**Comanche Peak Nuclear Power Plant, Units 3 & 4  
COL Application**

**ITAAC and Proposed License Conditions  
Revision1**

**Update Tracking Report**

**Revision 2**

Figure A.1-1 Ultimate Heat Sink System and Essential Service Water System  
 (Portions Outside the Scope of the Certified Design)

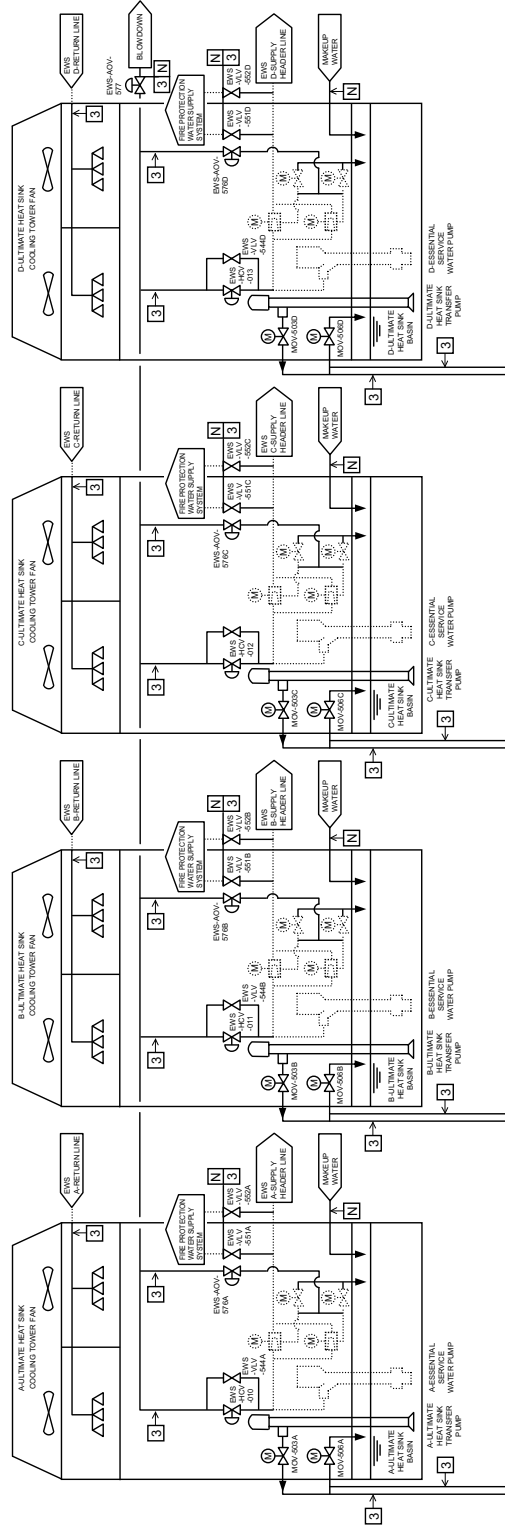
Change ID No.	Section	ITAAC Rev.1 Page *	Reason for change	Change Summary	Rev. of T/R
CTS-01208	Table A.1-2  Table A.1-3  Figure A.1-1	12 [20, 21]  13 [22]  14 [23]	Consistency with FSAR Chapter 9	Added isolation valves between the ESWS discharge strainer backwash, UHS basin, and CWS blowdown main header consistent with FSAR.	2
CTS-01208	Table A.2-2	18 [29, 30]	Consistency with FSAR	Revised the fifth column to indicate "Remotely Operated Damper."	2
CTS-01208	Table A.2-3	19 [31]	Consistency with FSAR	Changed unit heater equipment number consistent with FSAR.	2
CTS-01208	Figure A.2-1	20 [32]	Consistency with FSAR	Figure simplified to be consistent with FSAR.	2
CTS-01208	Table A.3-1 (sheet 2 of 4) #3	22 [37]	Consistency with FSAR	ITAAC was deleted because no penetrations in divisional walls exist.	2
CTS-01208	Table A.3-1 (Sheet 1 and 2 of 4) #2.b, #5.a, #5.b	22, 23 [36, 37]	Consistency with FSAR	ITAAC were deleted because barriers, penetrations, and doors are not credited for safety function	2
